Product Change Notification (PCN)

PCN Number	508388	Date Issued	April 20, 2020
Reason for Change	Manufacturing Process Change (Molex)		
Change Type Description	This letter is to inform you that the manufacturing process for the part(s) identified in this notice is changing. No changes will be made to the product as a result of this process change.		
Assessment of Change	Product will be fully qualified before it is shipped. Qualification reports will be available after below listed date		
Internal Molex Qualification Date	May 31, 2020		
Sample Availability Date (Changed Part)	May 31, 2020		
Planned Implementation Date	October 20, 2020		
Method of Identifying Change	Date code

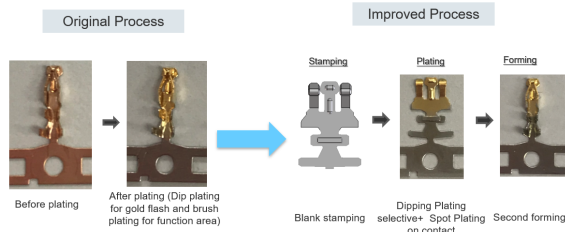
- Change the manufacturing process from Stamping (Blanking + Forming) → Plating to Stamping (Blanking) → Plating → Stamping (Forming) for Gold spotting process capability.
- The plating process change from Dipping + Brushing → Selective dipping + Spotting.
- The reason for change process is optimization process.
- Product Impact**
 - The impact is separate the one station stamping process by twice steps;
- Part Number Impact**
 - see attached impacted parts list
- Qualification Reports and samples available upon request after the date shown above
